## **PLANNING REFERENCE 23/04220/DIS**

Discharge of Condition 6 (Details of Services Internal & External) relating to Listed Building Consent 22/04272/LBC for the conversion of existing detached barn to self-contained ancillary accommodation and occasional holiday let use and refurbishment of distressed outbuilding affecting a Grade II Listed Building (re-submission)

LOCATION: Bronhaul, 6 High Street, Grinshill, Shrewsbury, Shropshire.

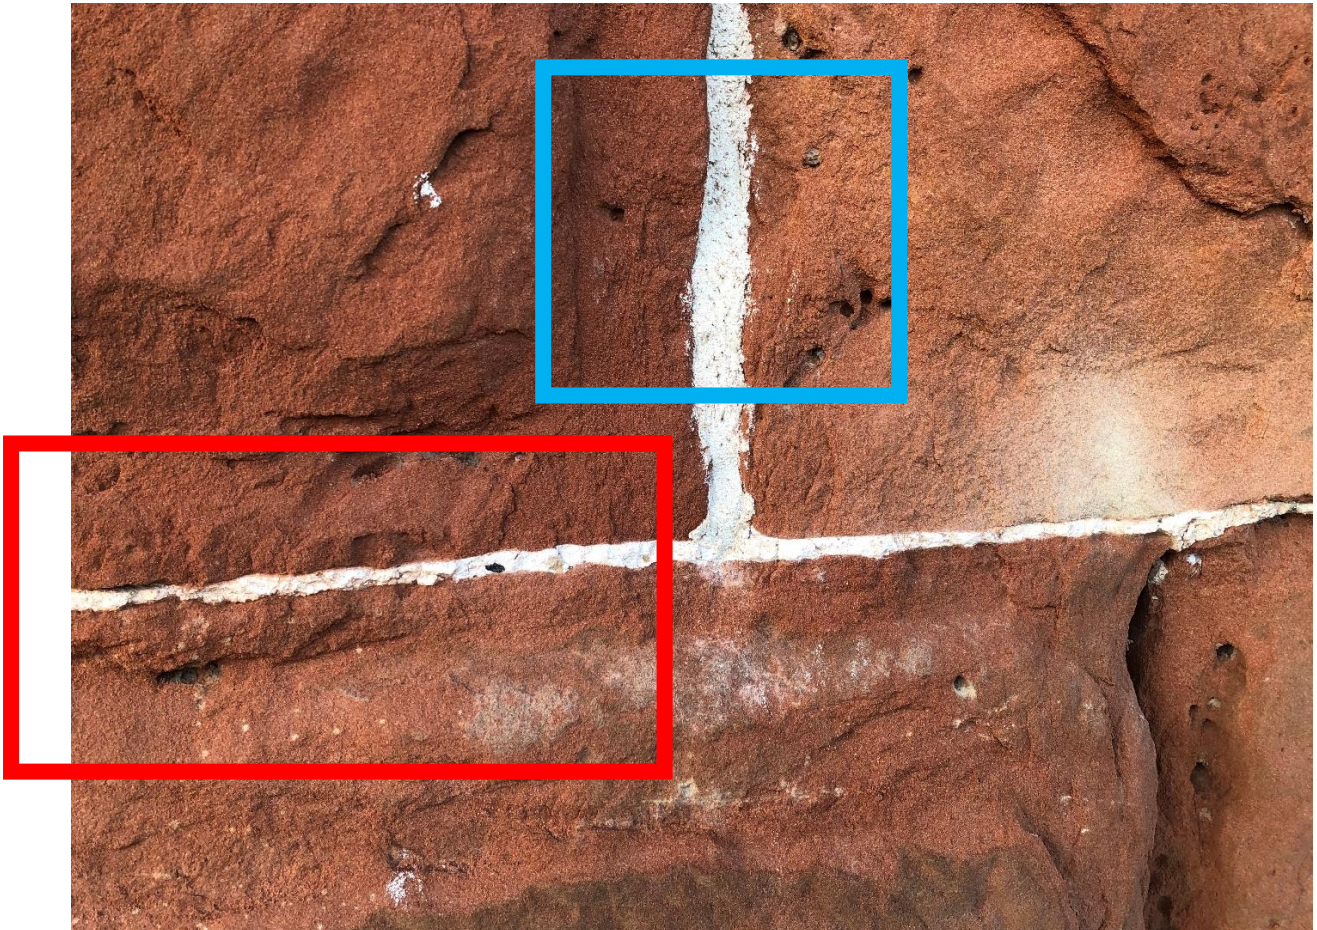
2. Door to kitchen - the case put forward is understood in terms of the privacy issues and it is not intended that the shutters are closed but pinned back. It is further understood that the doors may not have any historic value but the type of door opening was an openable solid timber door and the normal way to address these are to have a fully glazed door which in essence looks like it is open, hence the retention of an external door pinned back. If this needs to be addressed in terms of privacy then a more simple door style could be used, not one that appears whole domestic and alien to the overall appearance of this historic farm building/outbuilding. Whether the door is fully or partially glazed there is still the ability for overlooking into private areas in the courtyard. Unfortunately the condition cannot be discharged as there are no revised details to assess in any case.

Due to the front of the barn being visible from the road and neighbouring houses, as previously mentioned we are not keen to use a fully glazed door. This is further reinforced with the proposed plan to use the barn for occasionally holiday letting, with occupants not likely wanting a glass door opposite bedrooms and the kitchen.

In response to latest suggestion of plain door, we propose the following option:
